Planning Memorandum

Re: 15 Sunnyside Lane – Major Site Plan Review and CUP
WSB Project No. 020057-000

Memorandum

Re: 15 Sunnyside Lane – Major Site Plan Review
City of Sunfish Lake, MN
WSB Project No. 020057-000

SITE REMOVALS PLAN

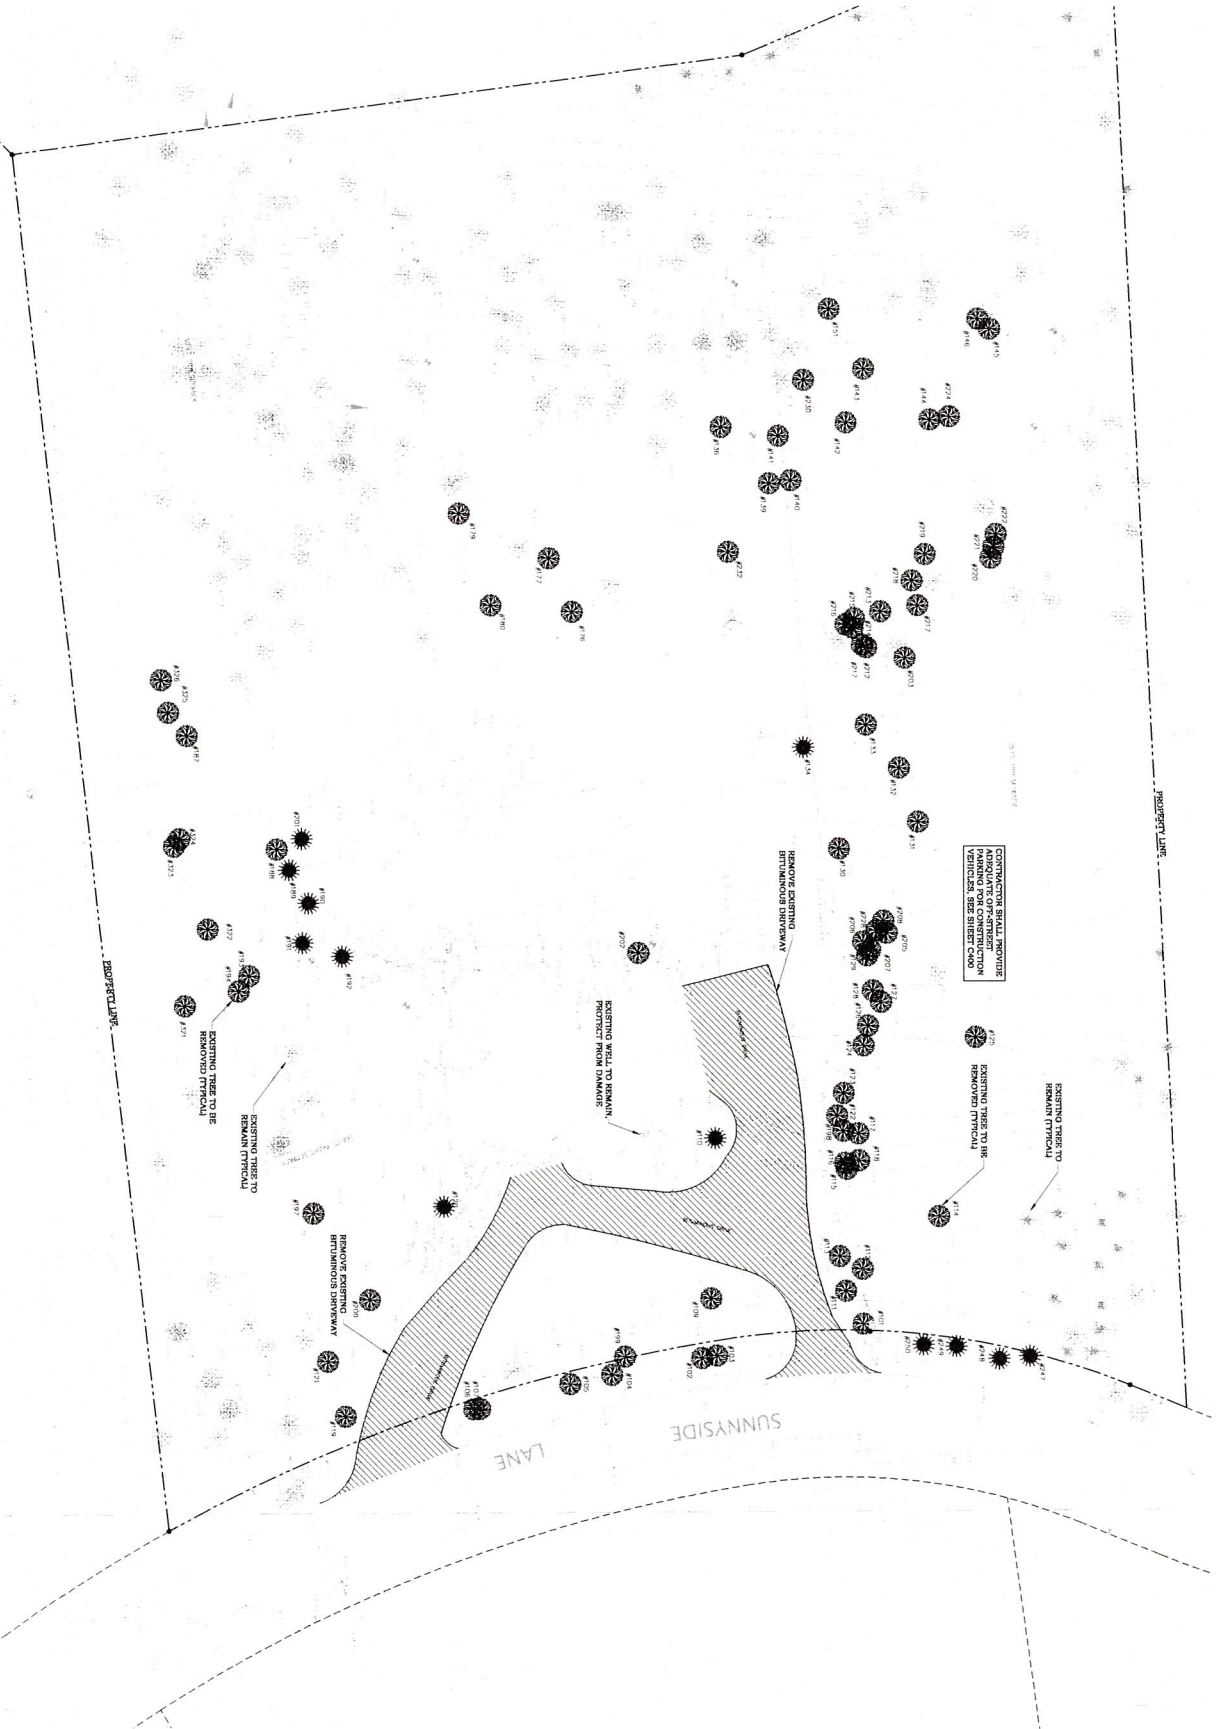
6. The home and driveway were removed last fall. Please update the demolition plan to reflect any additional removals (if any) and not show improvements already removed.

GRADING, DRAINAGE AND EROSION CONTROL PLAN

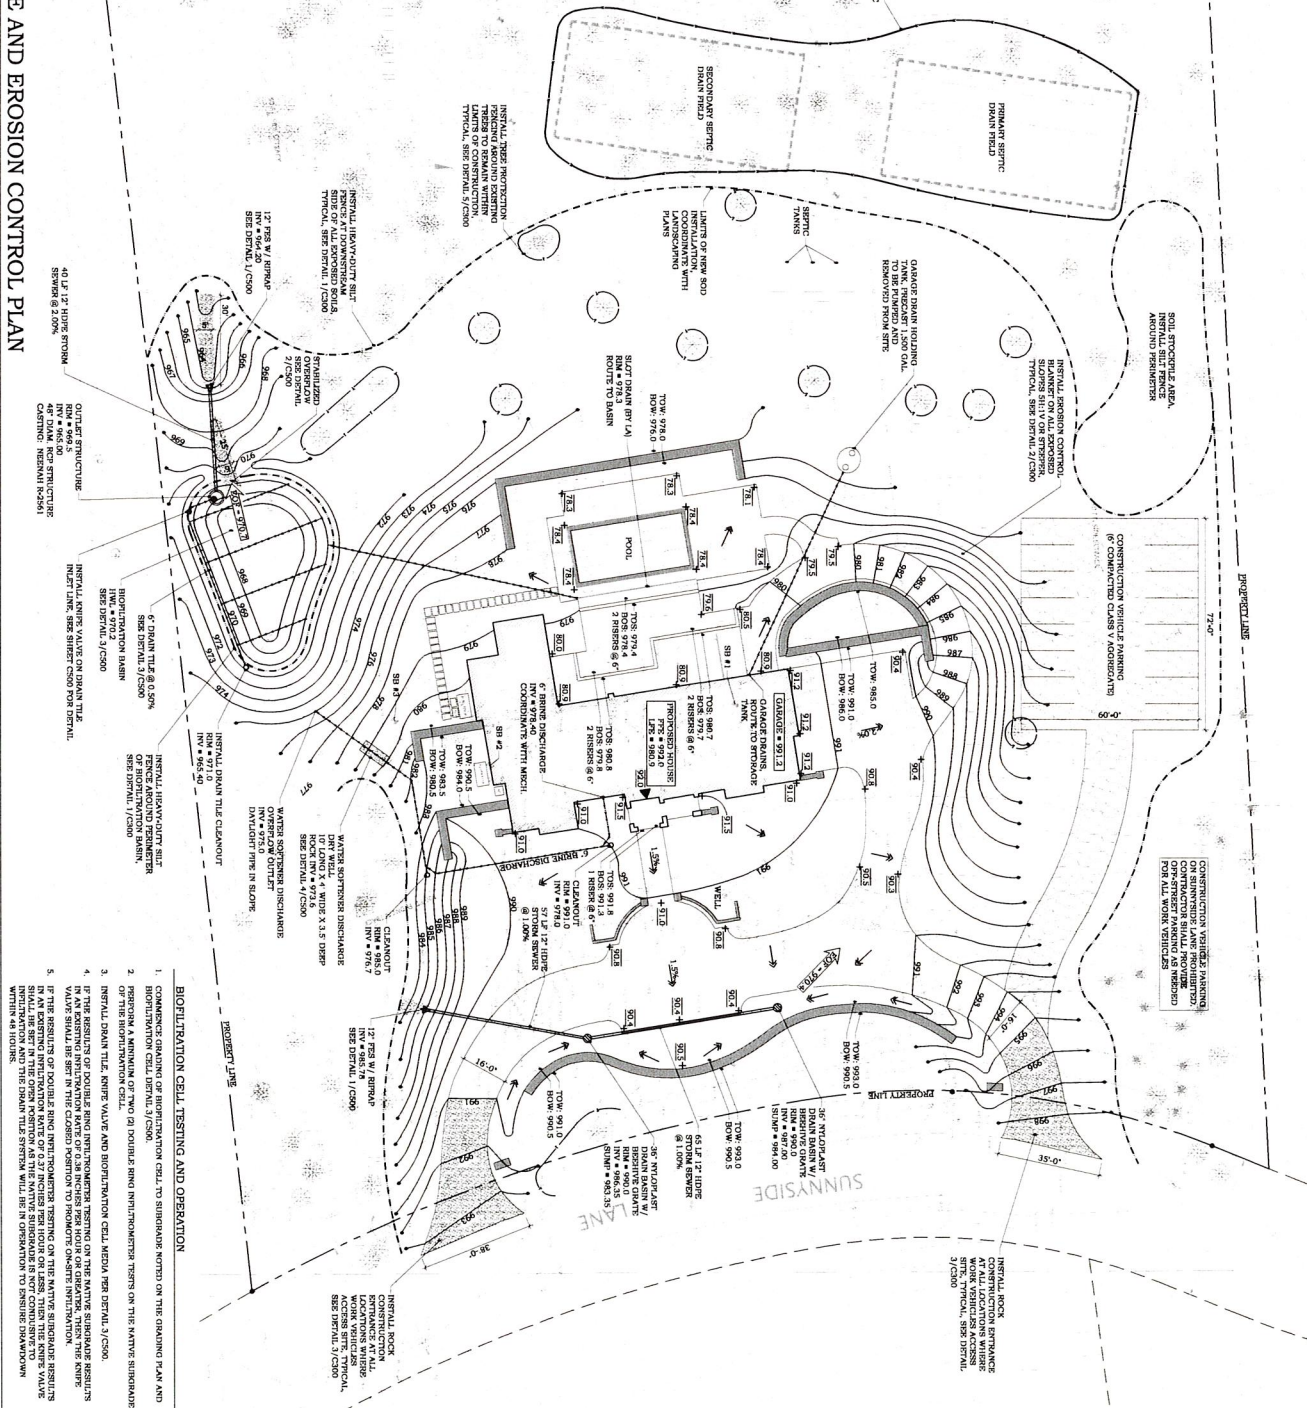
8. Please show the access to the temporary off-street parking area, and provide dimensions and proposed surface material and thickness of the off-street parking area. This should be shown and detailed on the grading and drainage plan.

3. The EOF elevation for the catch basins near the driveway should be updated as it is not consistent with the contours in the area. Assuming the elevation of the EOF is 990.4, there is only 0.8' of freeboard between the EOF and the garage elevation. It will be important to confirm the EOF is constructed to the correct elevation in the field to reduce the risk of flooding the garage.

1. The SWPPP narrative should be updated as it notes incorrectly that the site doesn't disturb over one acre of impervious.
2. Rip rap dimensions were noted to have been added to the grading plan but it does not appear that the dimensions were added.
3. Existing drainfield location should be shown on the plans. Provide plans for proposed drainfield/ septic design.
4. Show orange construction fence around proposed primary and secondary drainfield areas.
5. Plan shows "Limits of new sod" beyond site grading and silt fence. Please show silt fence outside of new sod limits and confirm that no grade changes will occur in that area.
6. Show a minimum length dimension for the gravel construction entrance(s).
7. Show detailed dimensions for each proposed driveway/ entrance on to Sunnyside Lane. Dimension the proposed driveway on the plans.

1. Silt fence that is shown to run perpendicular to the contours should not be shown, as that would do more harm than good. Orange Construction fence should be shown in those locations instead.
2. More biologs may need to be used in lieu of silt fence from comment #1. The City Engineer must be consulted prior to this work being initiated to discuss additional erosion control measures that will likely be needed at the site.
